RESIDENTIAL STANDARDS IMPROVEMENT PROGRAM SUBCOMMITTEE

MEETING AGENDA

**RSIP SUBCOMMITTEE
AMENDMENTS UNDER CONSIDERATION
PROGRESS REPORT
1-6-10**

RSIP Amendment Suggestions

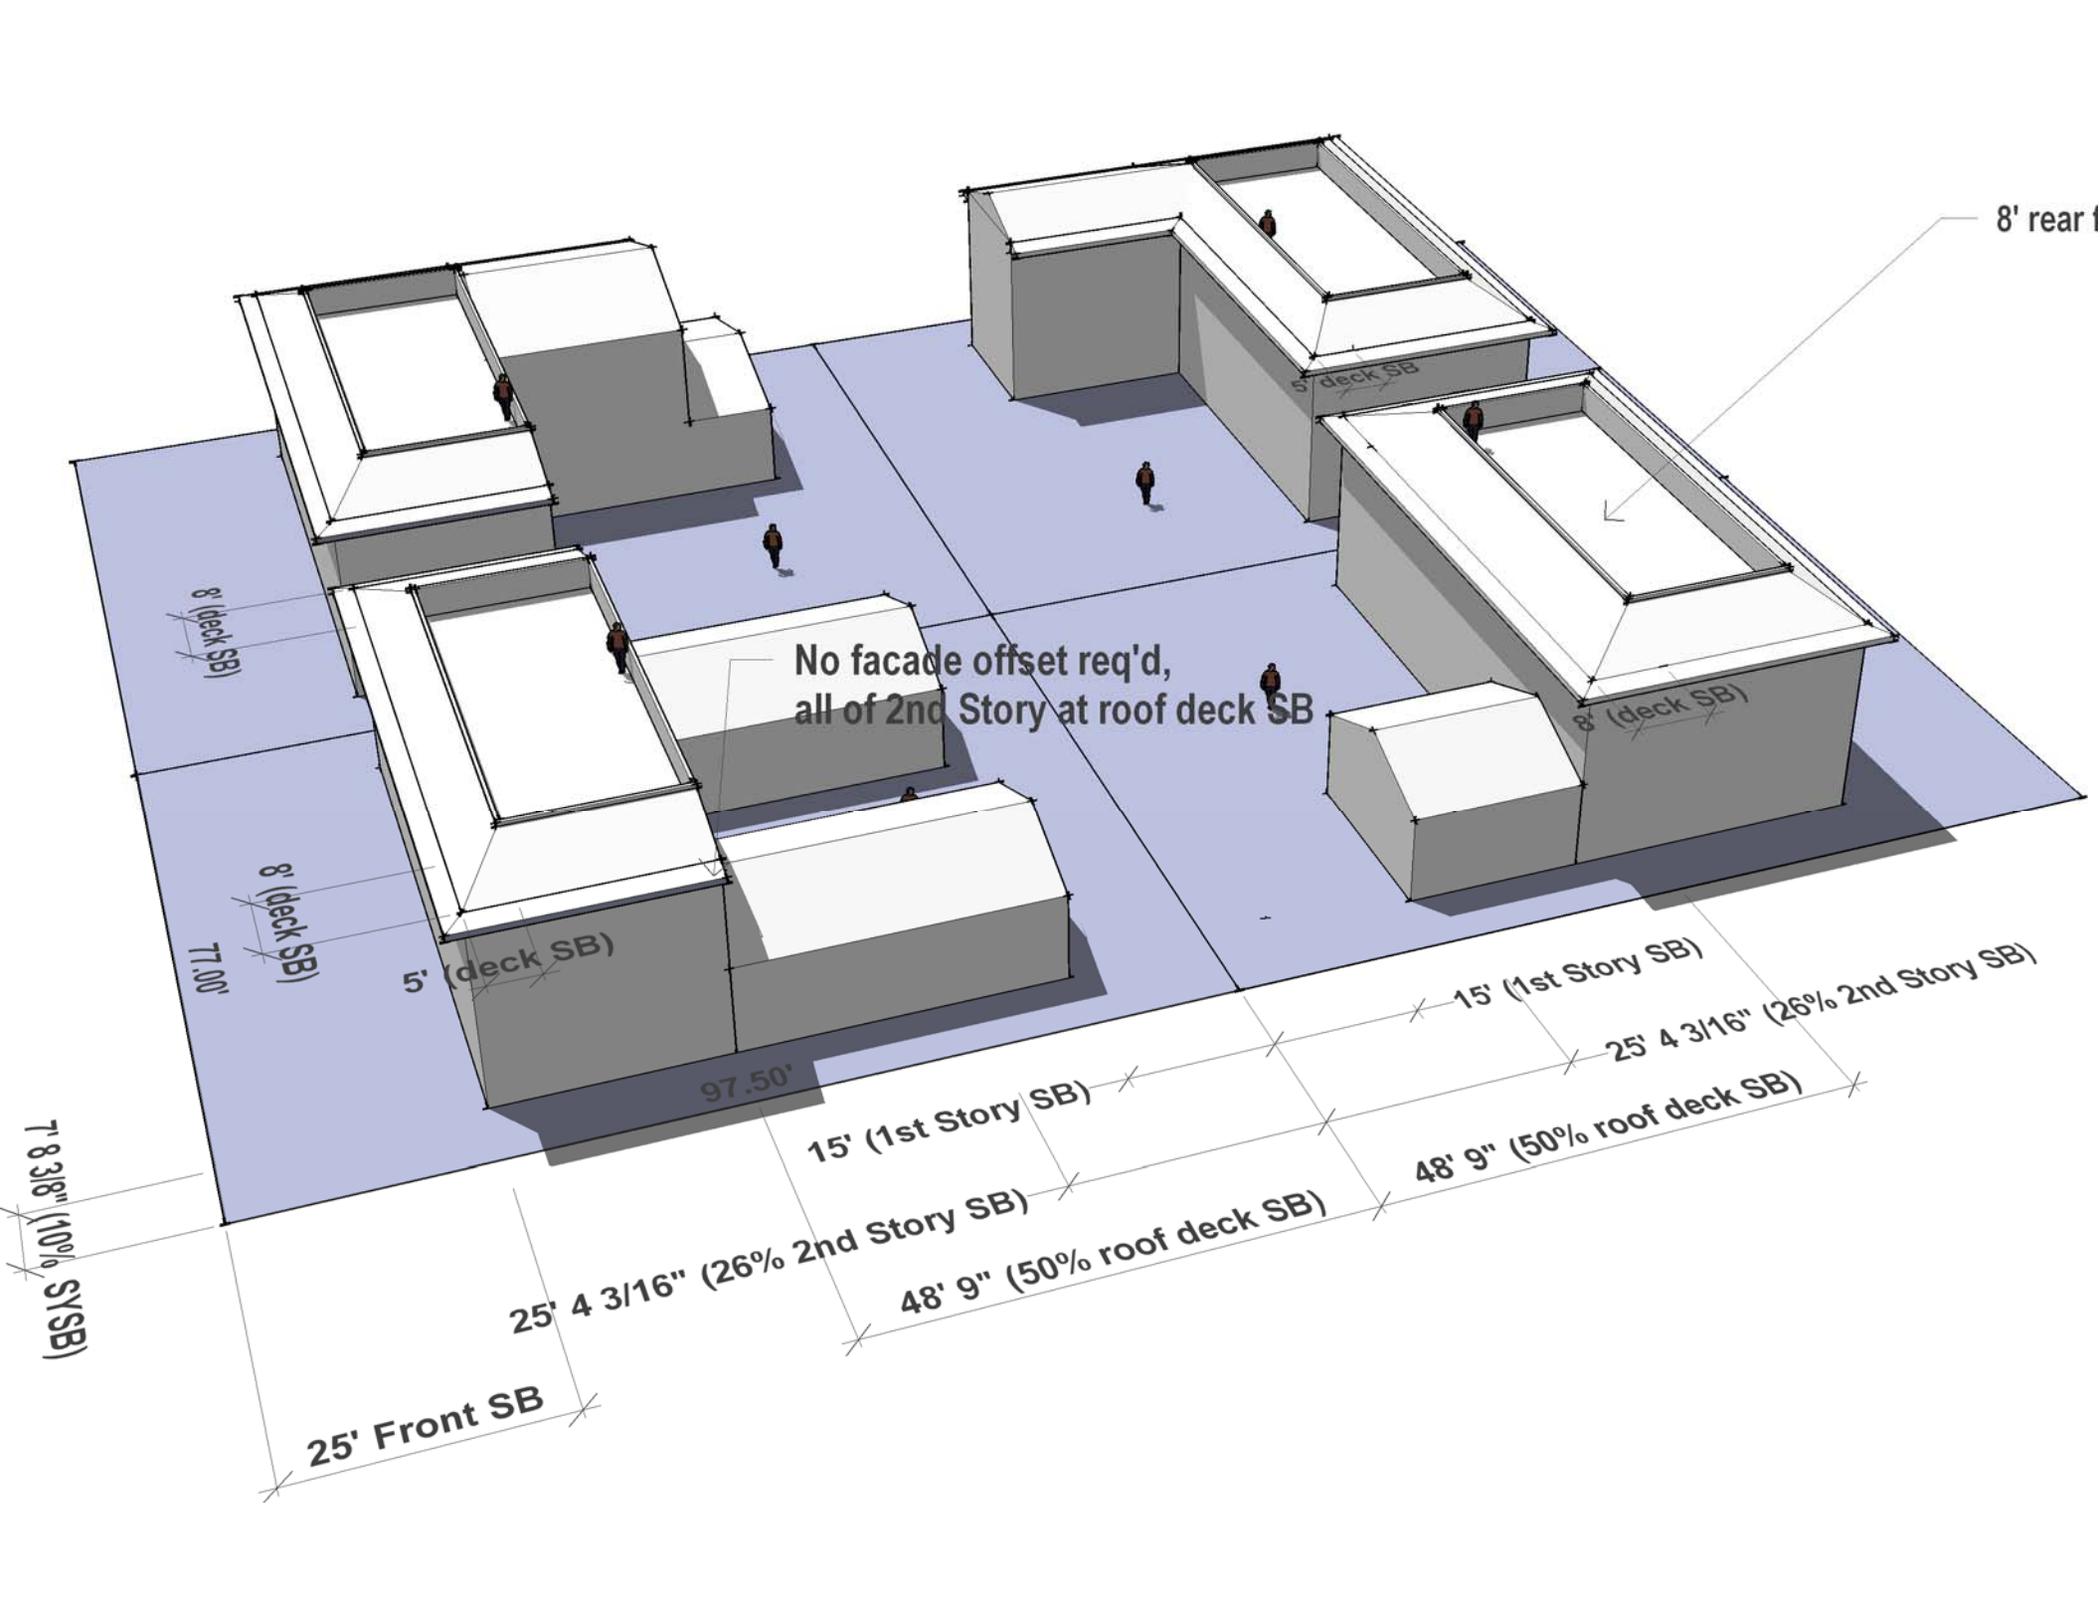
Reviewing:

1. Review of side yard setbacks for roof decks above 14’ in height (86.08.090).
 - a. Existing:
An interior side yard setback of twice the required side yard with a maximum of eight feet from the side facade;
 - b. Proposed:
An interior side yard setback from the side façade of the structure as follows;

Lot width	Facade setback required
25 feet or less	3 feet
Greater than 25 feet, up to 50 feet	5 feet
Greater than 50 feet	8 feet

2. Review of 2nd story rear yard setback for large lots (86.08.050C).
 - a. Existing:
For all lots except those with a rear property line adjoining a public park or bay, there shall be a second story rear yard of not less than 20 percent of the depth of the lot for lots 100 feet or less in depth and 26 percent of the lot depth for lots greater than 100 feet in depth. However, in no case would the lot area of the required second story rear yard be required to exceed 20 percent or 26 percent of the gross lot area, respectively. (The handle portion of a panhandle lot shall be excluded from lot depth calculations.)
